**Proposed Obstacle Lighting Scheme for Craig Watch Wind Farm, Moray**

Reference: Aviatica Report No. 23/1086/RAM, June 2023

**CRAIG WATCH WIND FARM, MORAY:  
REVISED PROPOSAL FOR REDUCED  
LIGHTING SCHEME**

**Report No.23/1086/RAM**

Figure 2: Craig Watch wind farm: 2023 layout and proposed revised lighting scheme

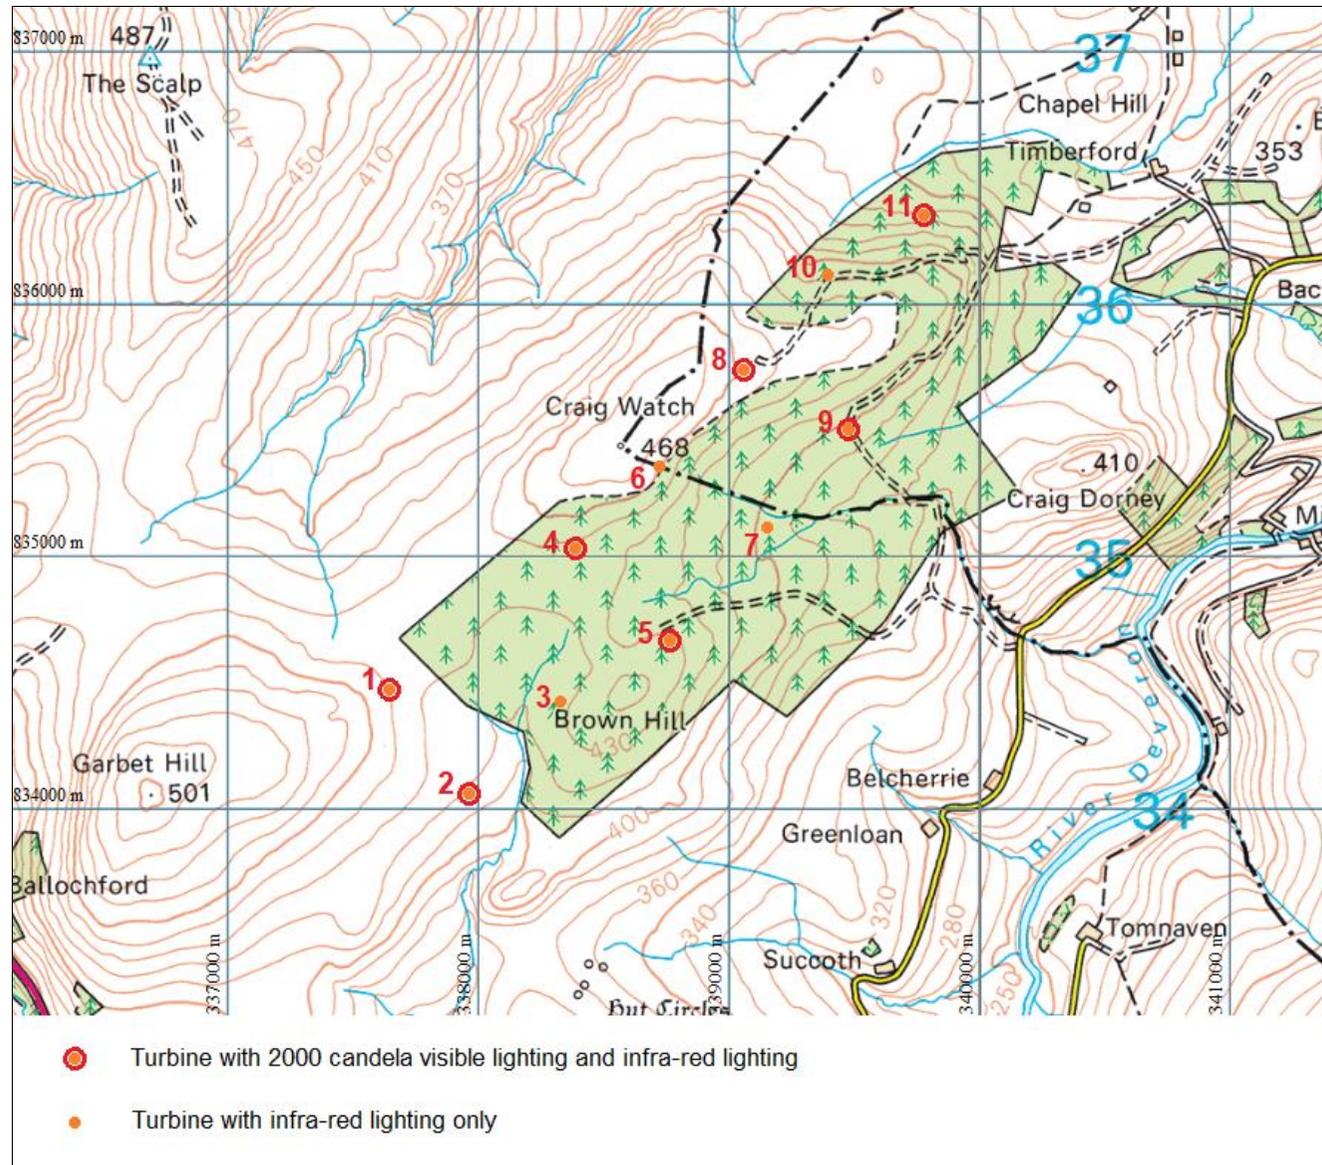
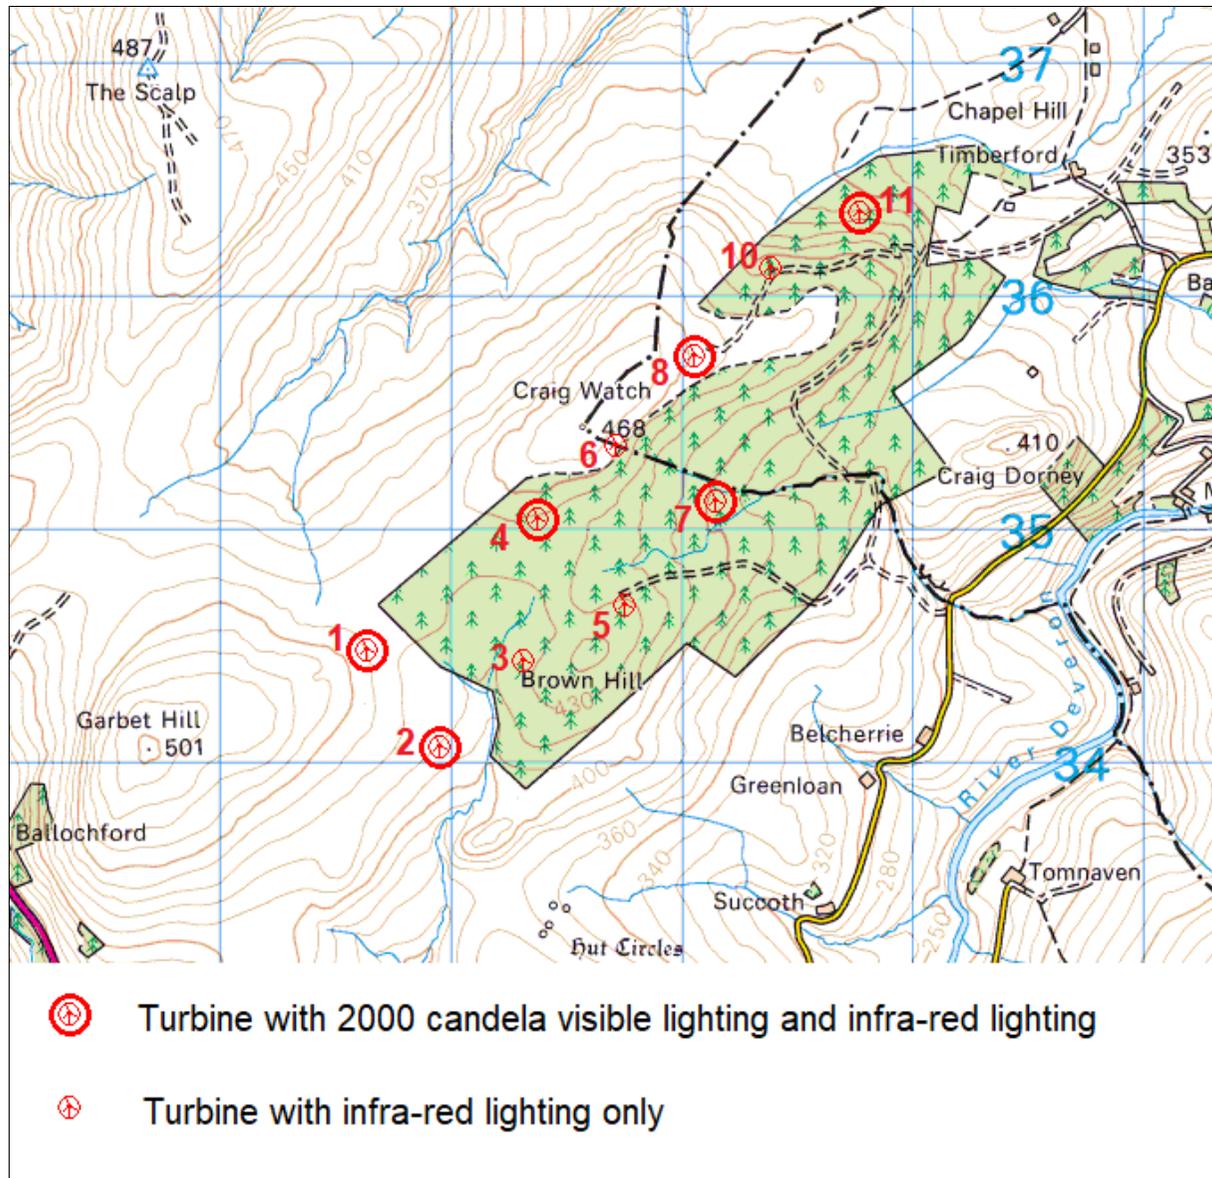
1. Thank you for the report at reference. The attached report provides a revision to the proposal for an obstacle lighting plan for the Craig Watch wind farm because of a reduction in the numbers of proposed turbines (removal of turbine 9). This impacts the reduced obstacle lighting scheme that the CAA agreed in our letter dated 28 May 2022. This document supersedes the 28 May 2022 agreement.

6. As a result, the CAA agrees a variation to the lighting requirements specified in the ANO Article for the Craig Watch wind farm, under provisions given in the Air Navigation Order (ANO) Article 222 section 6, as per the following:

- medium intensity steady red (2000 candela) lights on the nacelles of turbines T01, T02, T04, T07, T08 and T11;
- a second 2000 candela light on the nacelles of the above turbines to act as alternates in the event of a failure of the main light;
- the lights on these turbines to be capable of being dimmed to 10% of peak intensity when the lowest visibility as measured at suitable points around the wind farm by visibility measuring devices exceeds 5km;
- infra-red lights to MoD specification installed on the nacelles of turbines T01, T02, T03, T04, T05, T06, T07, T08, T10 and T11.

7. Intermediate level 32 candela lights are not required to be fitted on the turbine towers.

1.6 The design of the proposed revised lighting scheme is set out in Section 3 below. Figures 1 and 2 below show, respectively, the original CAA-approved lighting scheme and the current proposal for a revised lighting scheme.
